Memorandum to the City of Markham Committee of Adjustment

File: A/092/20
Address: 19 Thorny Brae Drive – Markham, ON (Thornhill)
Applicant: Elina Eidkham
Agent: MDI Development Inc.
Hearing Date: February 3, 2021

SITE PLAN

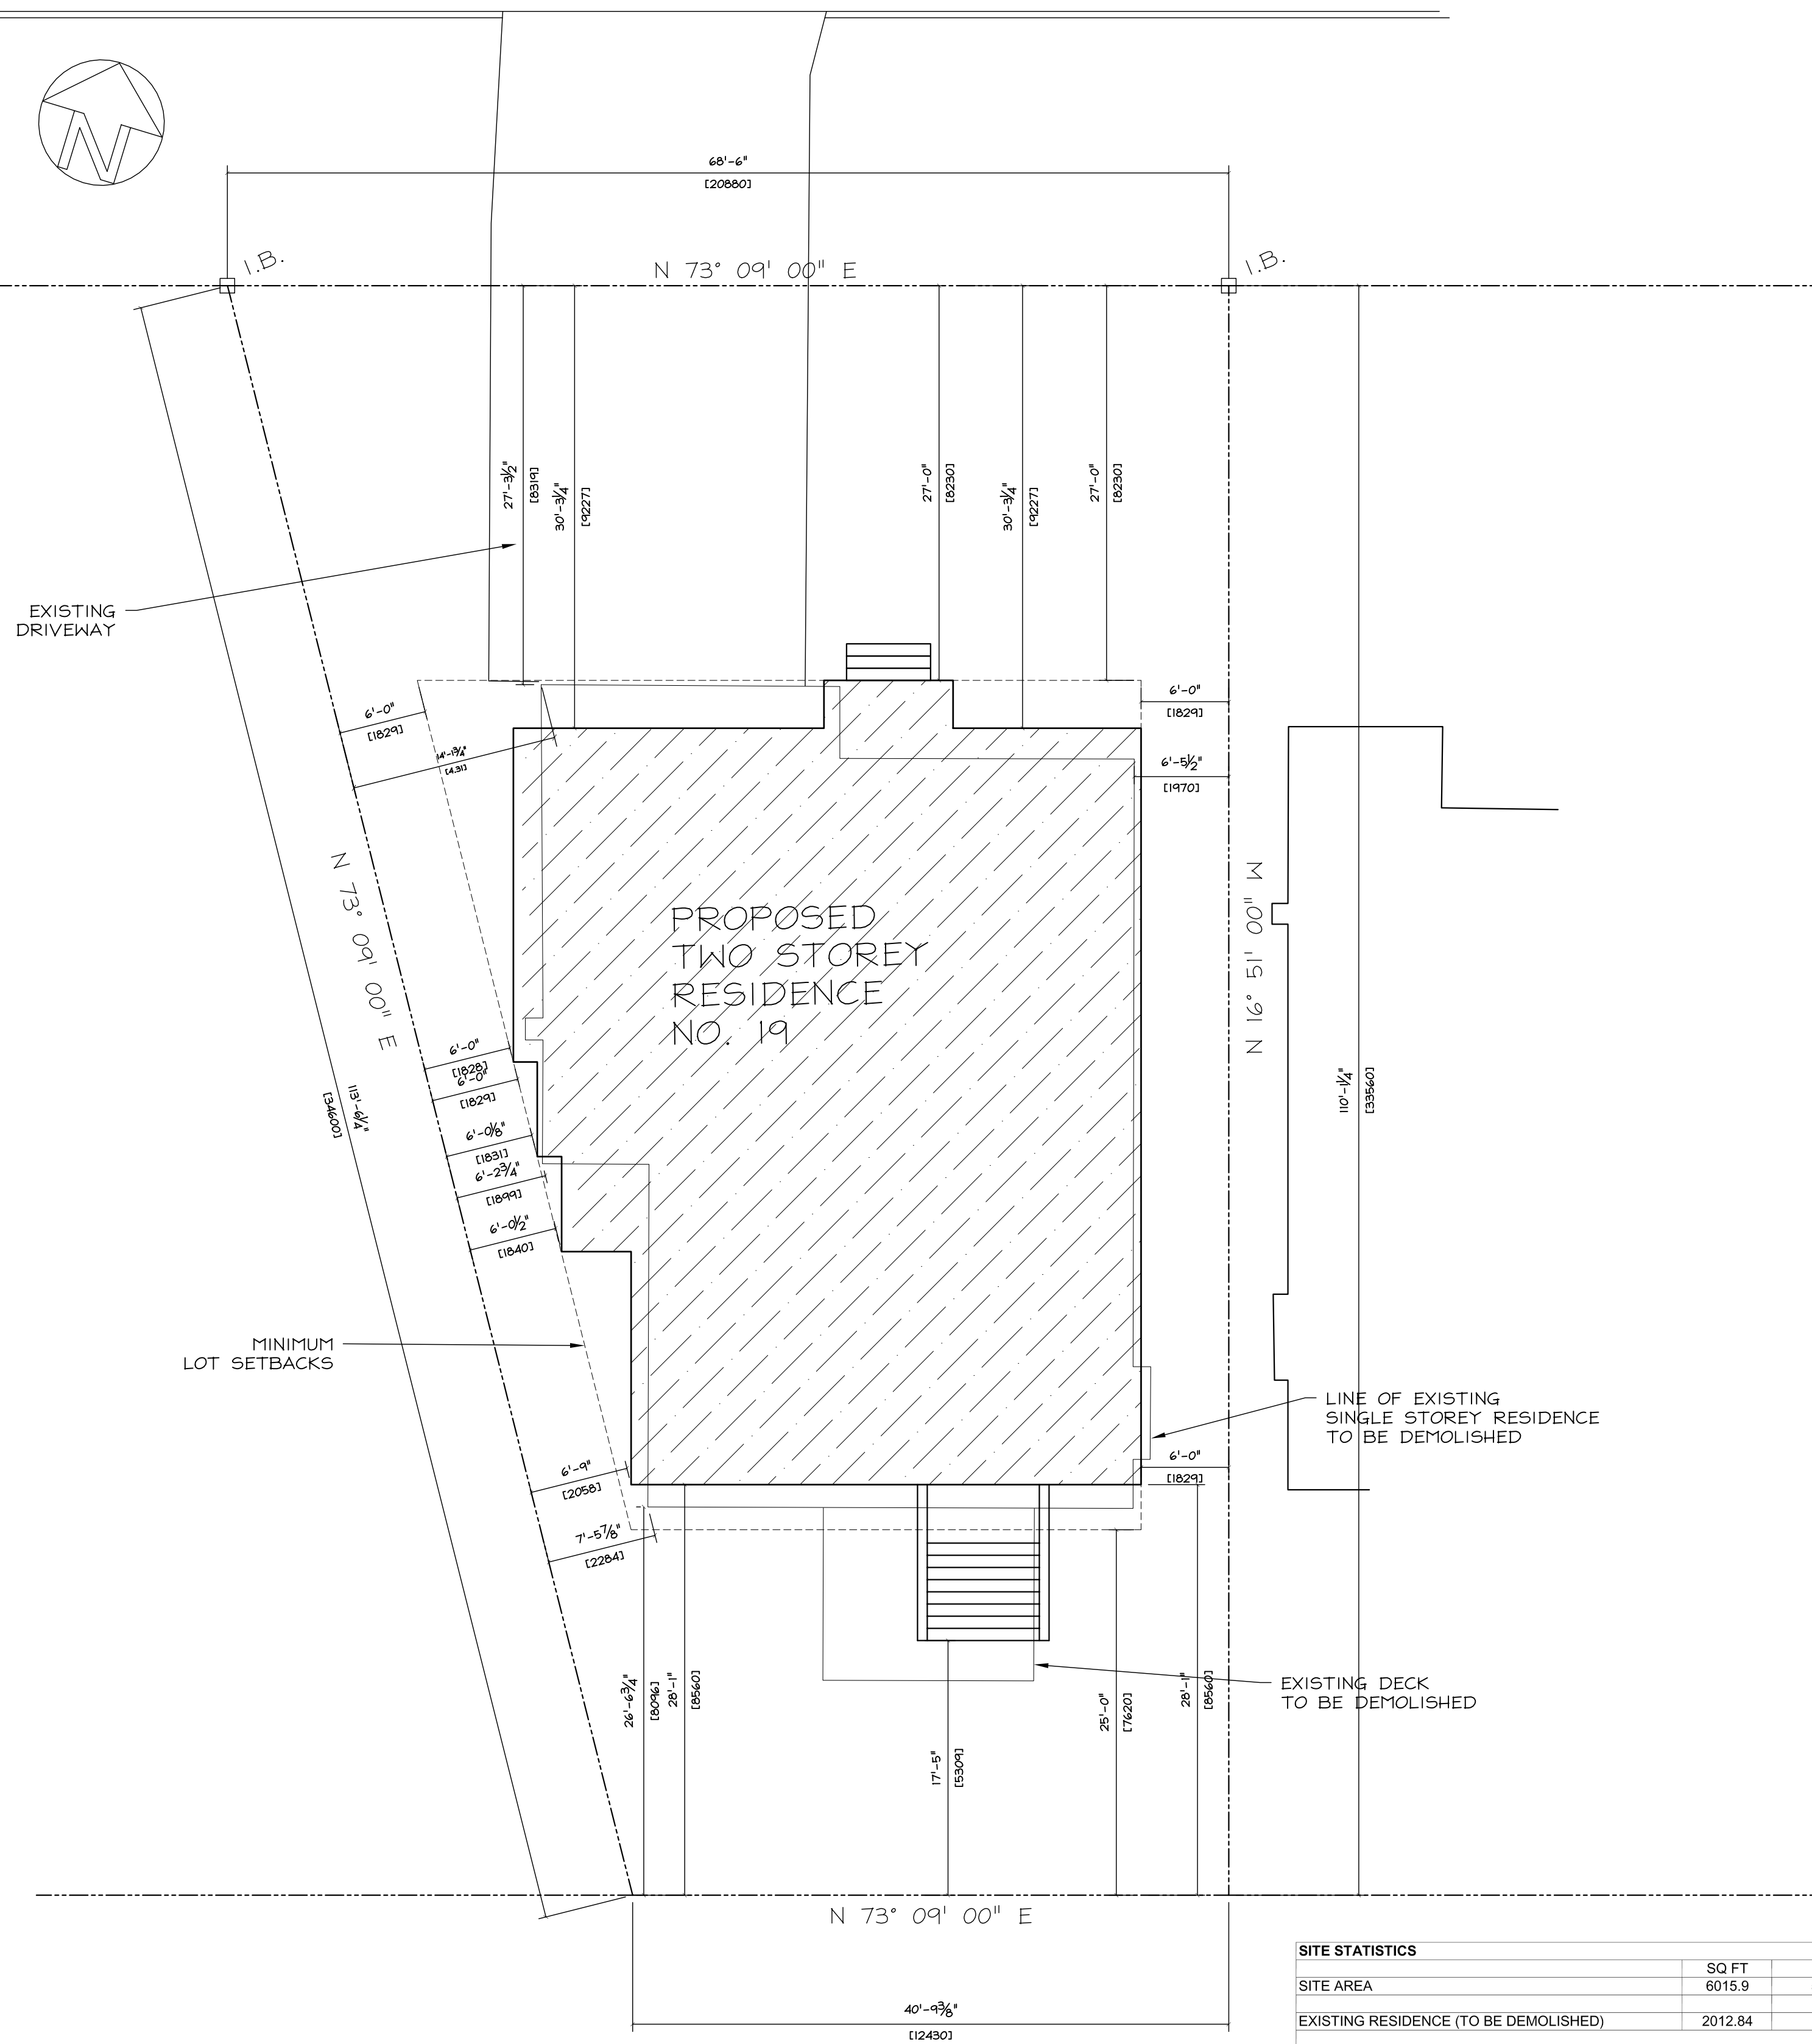
The applicant is requesting relief for a maximum lot coverage of 34.76% or a floor area of 193.27 m² (2,091.07 ft²), whereas the By-law permits a maximum lot coverage of 33.33%

or a floor area of 186.27 m² (2005.04 ft²). This is an increase of approximately 1.43% or 8.0 m² (86.03 ft²).

Staff are of the opinion that the proposed increase in lot coverage will not significantly add to the scale and massing of the dwelling, and the resultant dwelling is generally consistent with what the By-law permits.

1 PROPOSED NORTH ELEVATION
A-3 SCALE 3/16"=1'-0"

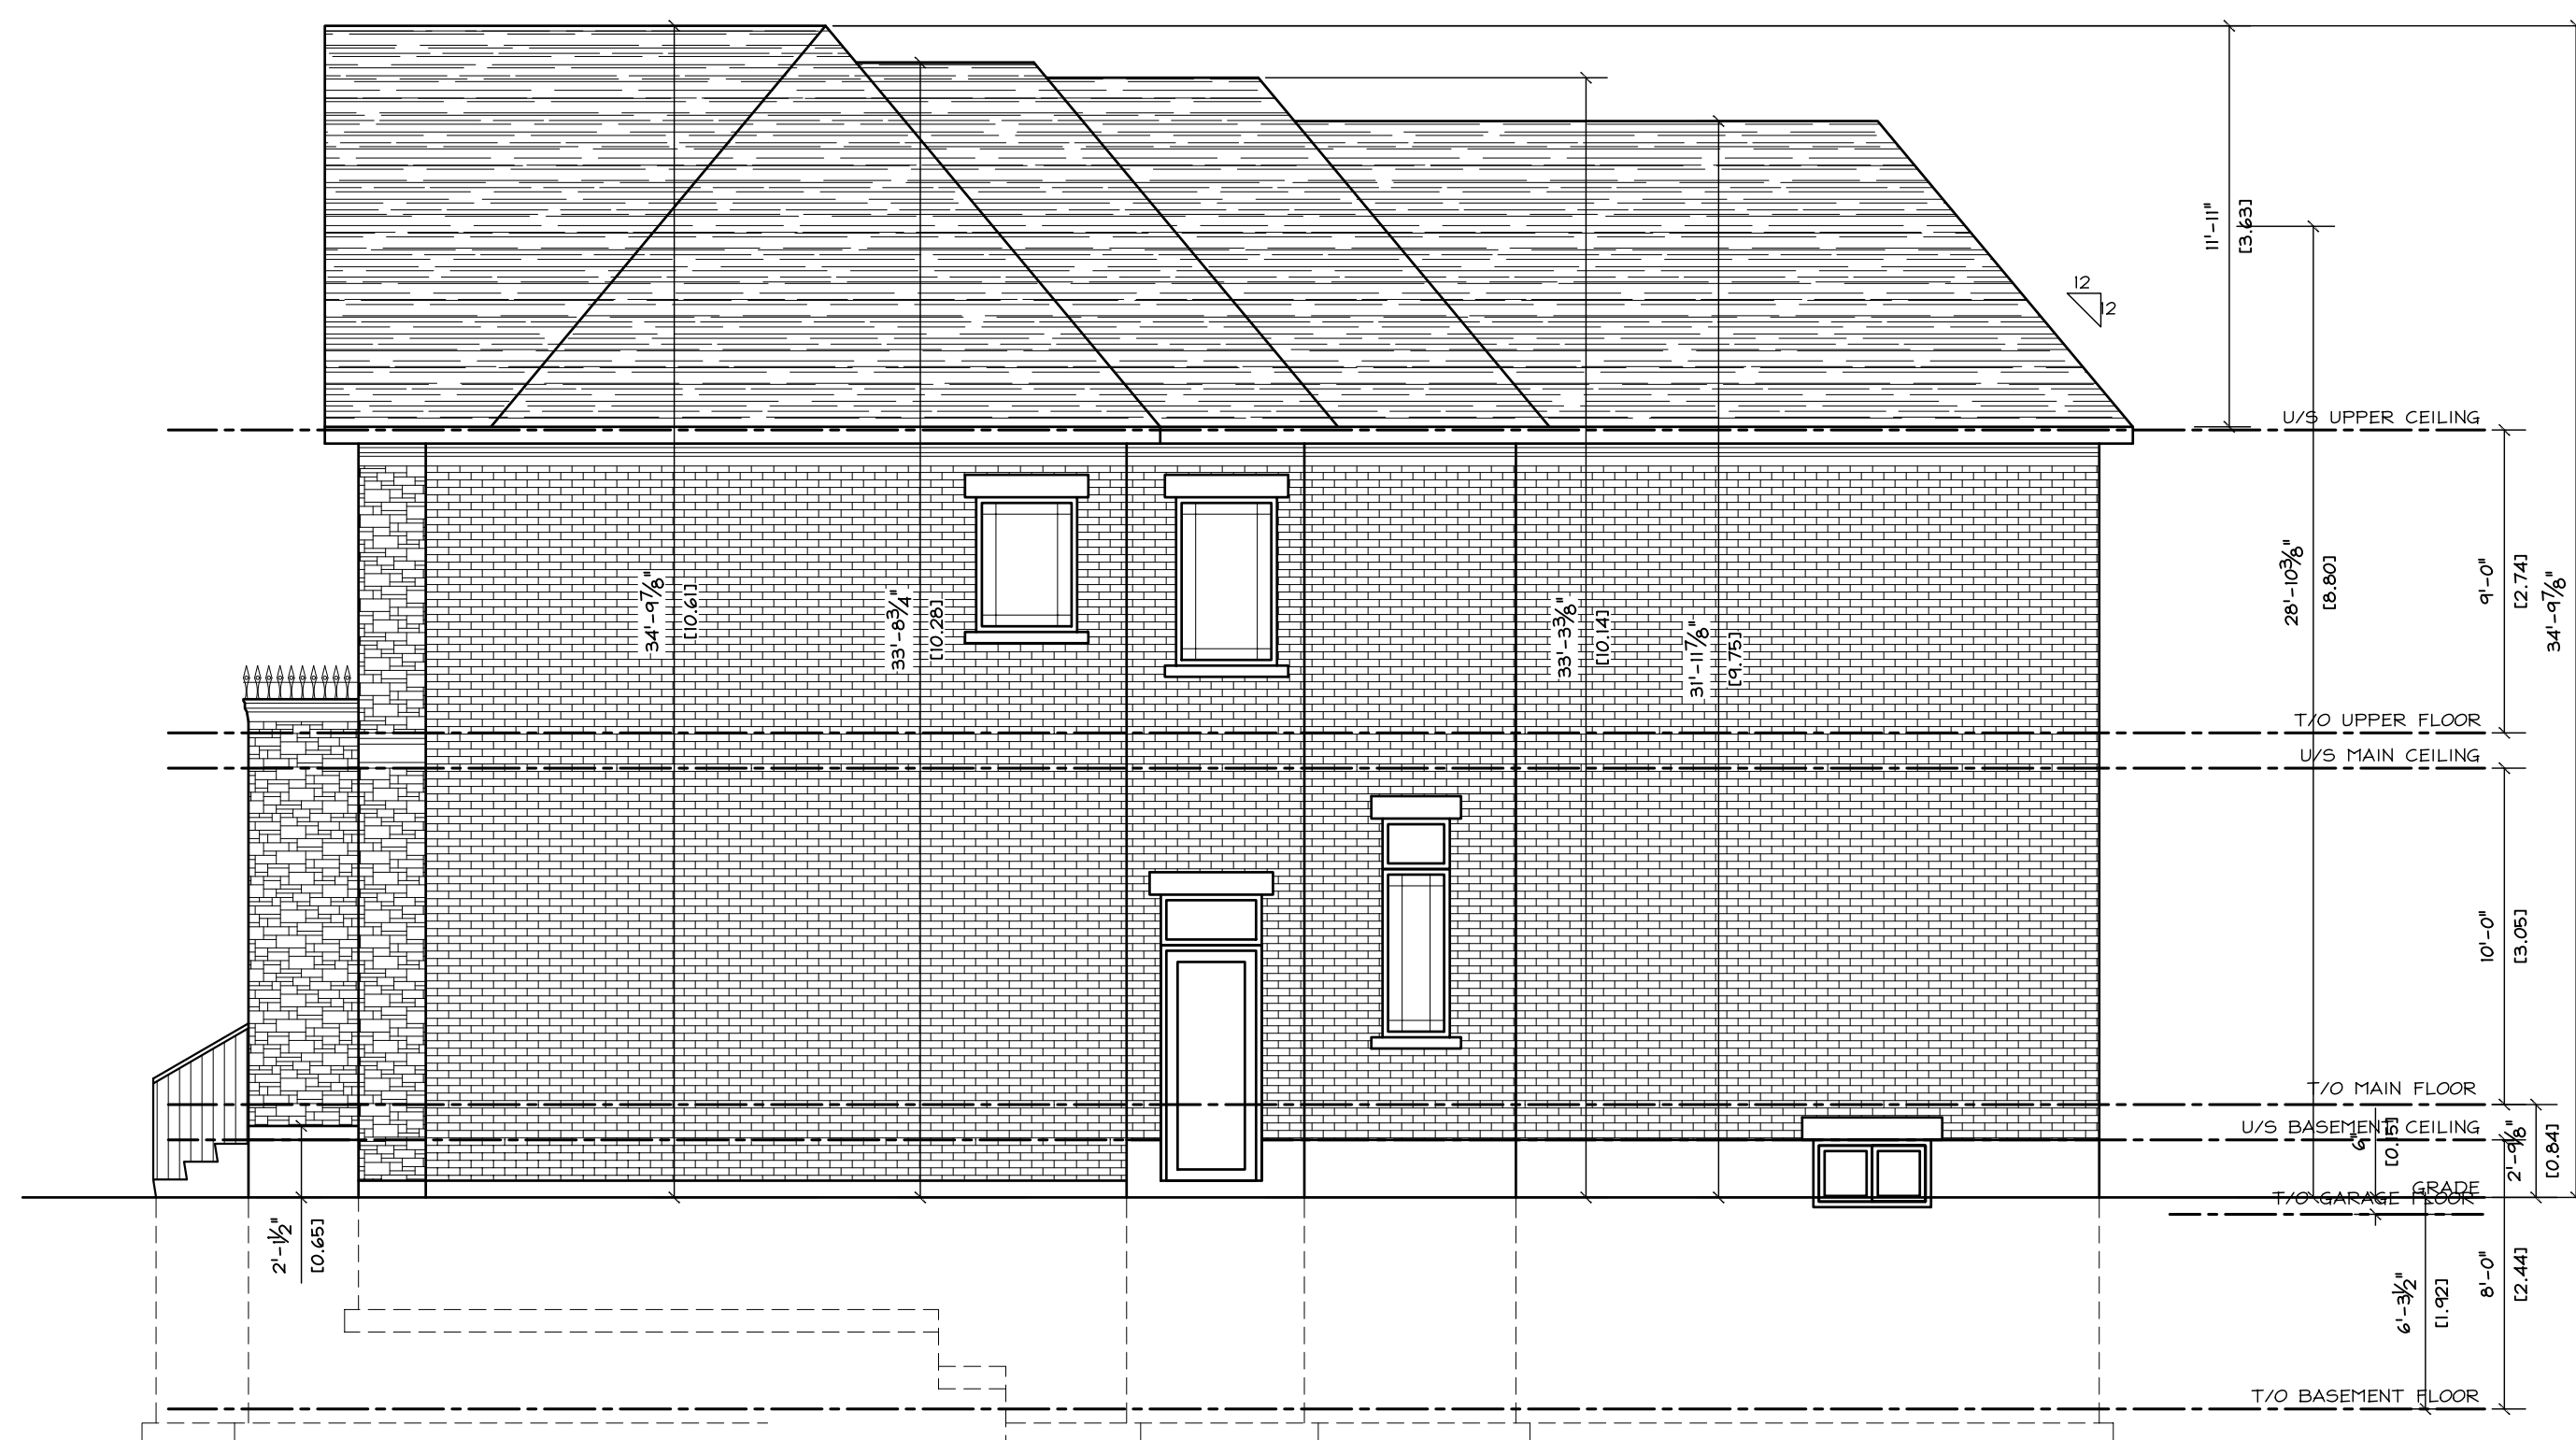
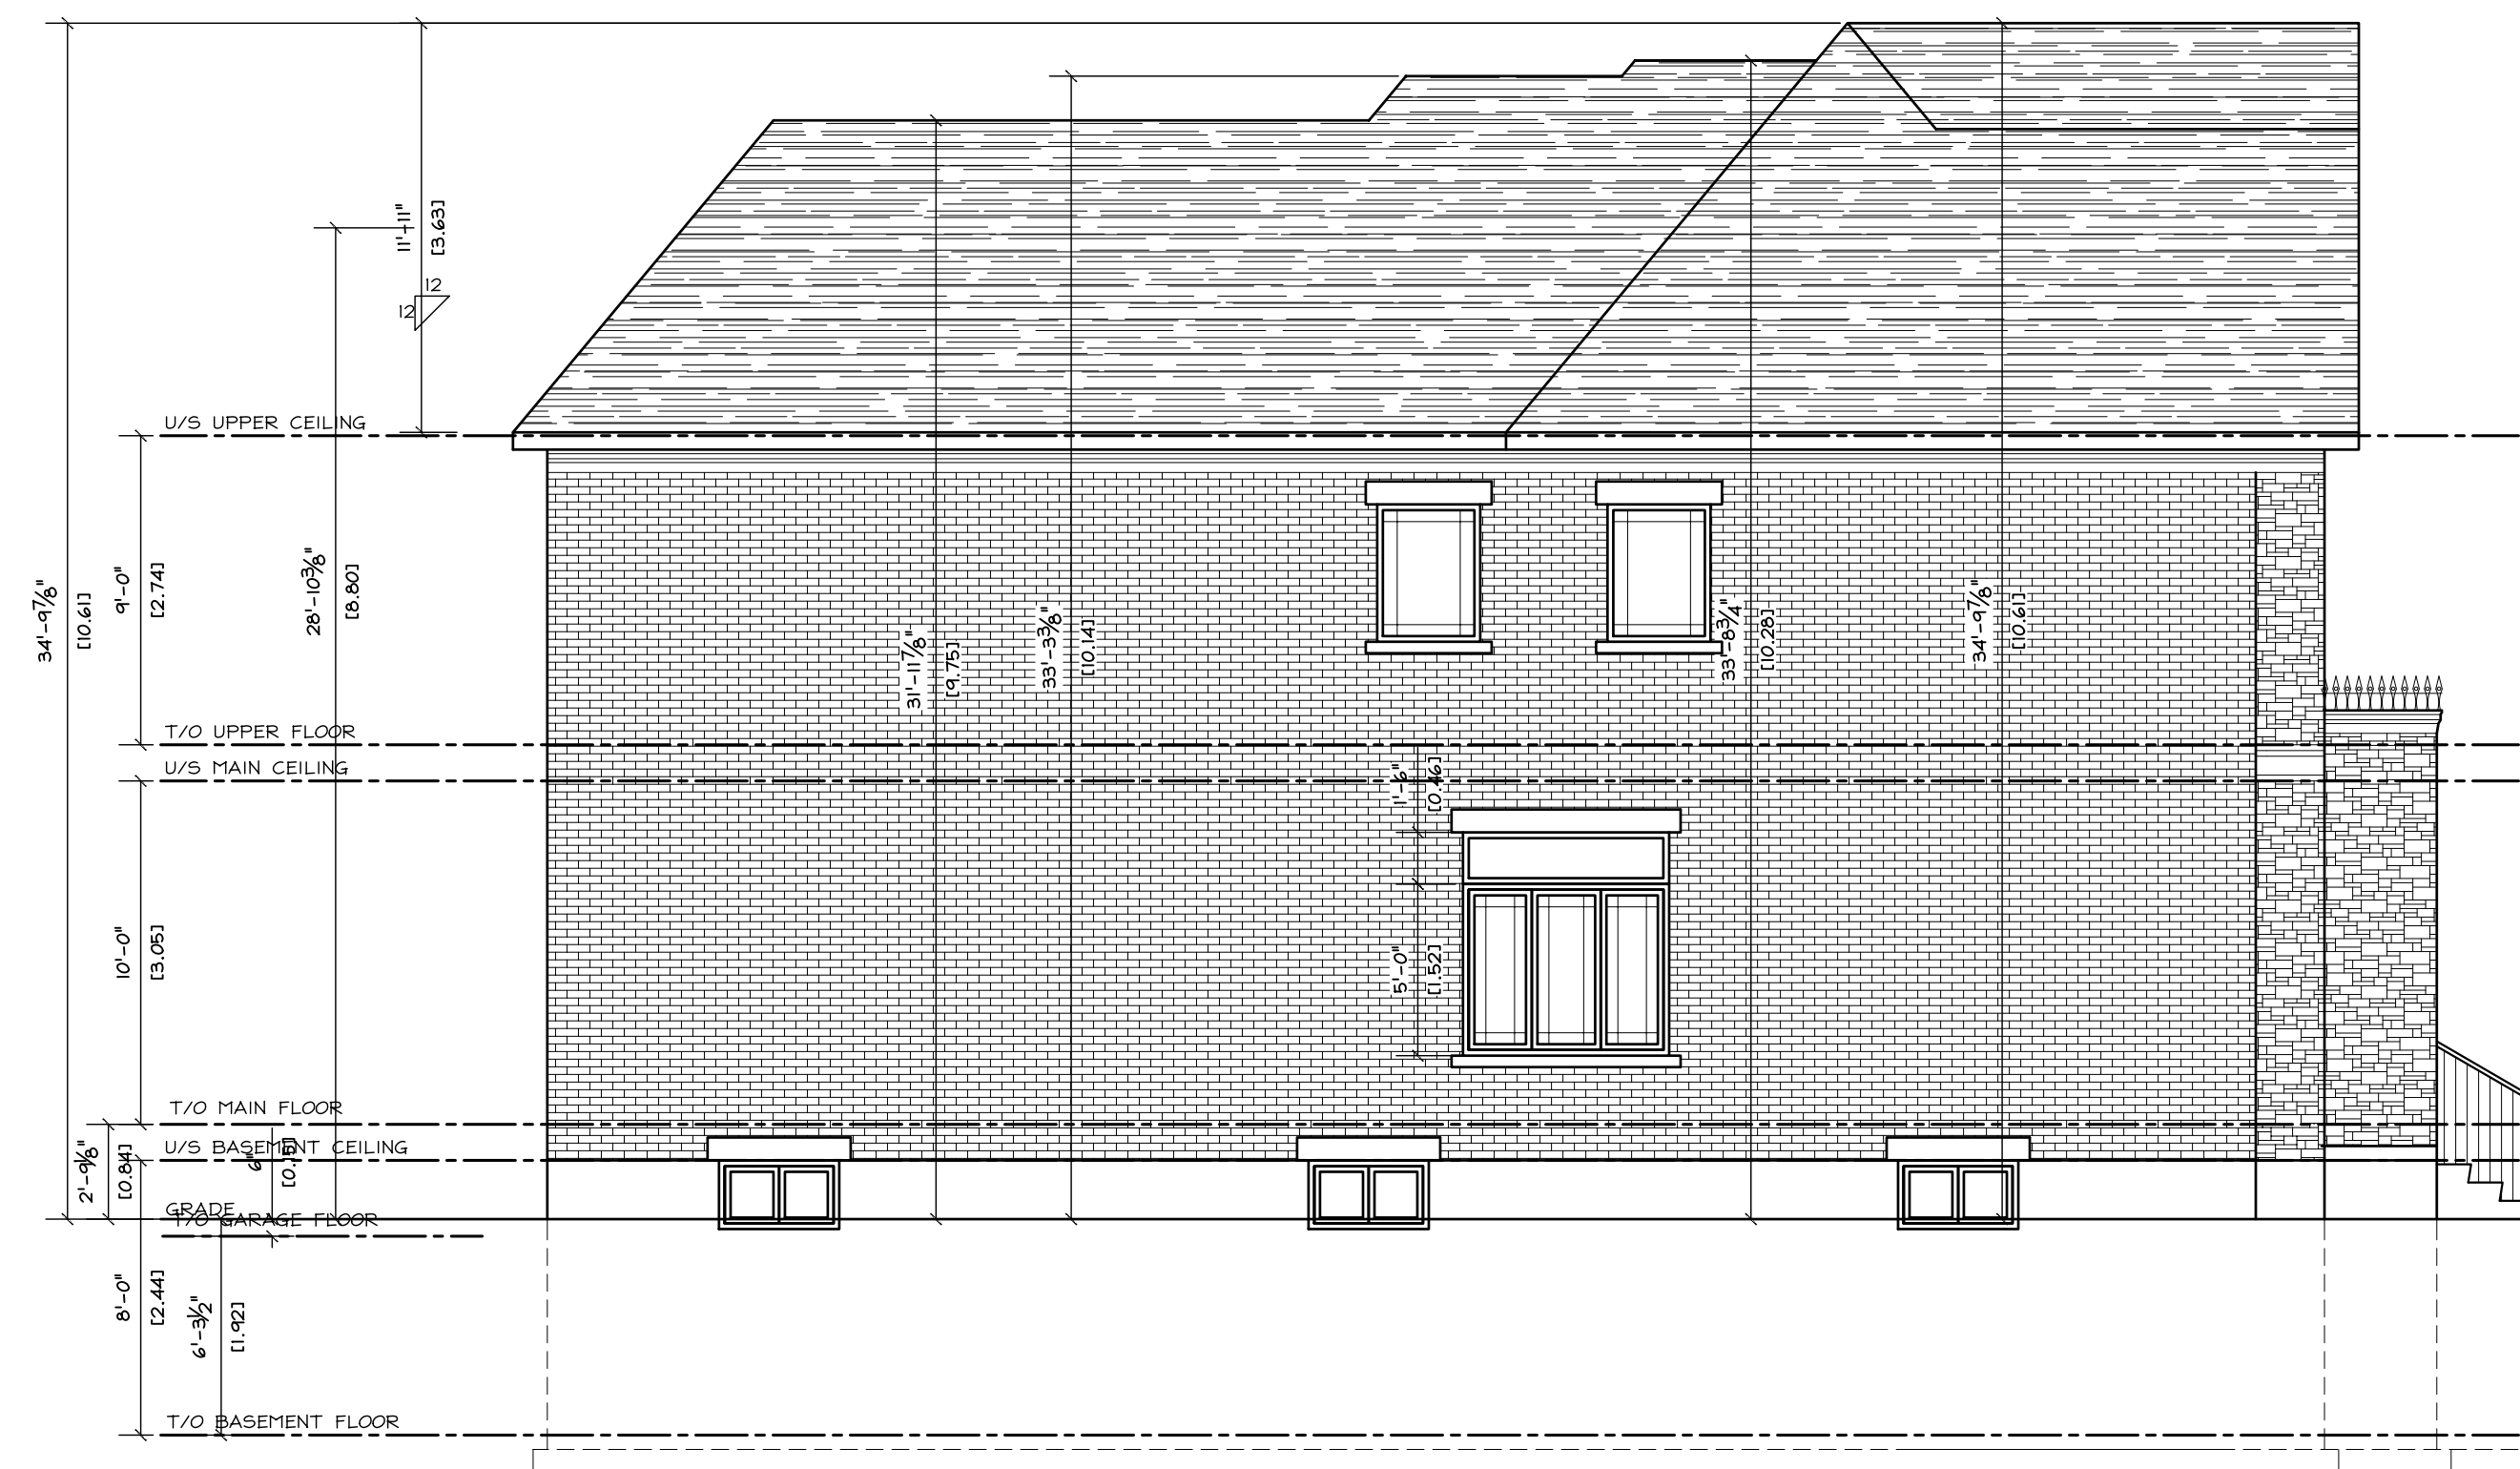
The applicant is requesting a maximum building height of 28.87 ft (8.80 m), whereas the By-law permits a maximum building height of 25.0 ft (7.62 m). This is an increase of 3.87 ft (1.18 m).

The applicant initially proposed a height of 9.10 m (29.86 ft). New infill developments should have regard to the height and massing of established homes to ensure the overall character of the neighbourhood is maintained. In considering the scale of the existing built form within the surrounding area regulated by the By-law permissions in effect, staff had some concern with the initial variance request. The applicant has worked with staff to reduce the height of the proposed dwelling, and while the reduction is minimal, staff are of the opinion that the revised height is more to scale with other existing dwellings within the surrounding area built circa 1967.
